Remarks

Atsuhiro TOBITA  
Serial No. 10/615,783  
Response to Office Action dated October 15, 2004

**Amendments to the Drawings:**

FIG. 1

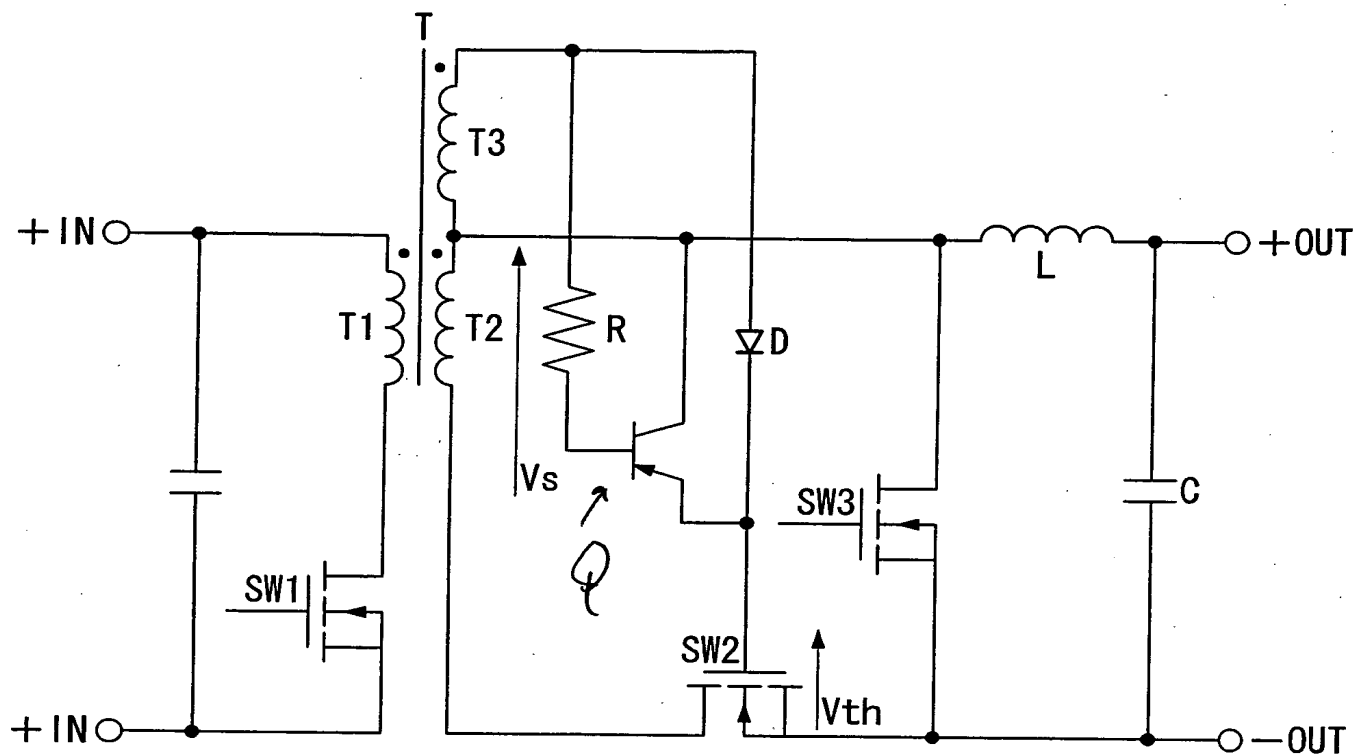
As requested, Figure 2 has been provided with a label --Prior Art--. In addition, the label Q has been added to Figure 1 to reference the auxiliary switch.

The attached sheet of drawings includes changes to Figures 1 and 2. This sheet, which includes Figures 1 and 2, replaces the original sheet including Figures 1 and 2. In Figure 1, a reference element "Q" and a lead line to the auxiliary switch has been added. The legend --Prior Art-- has been added to Figure 2.
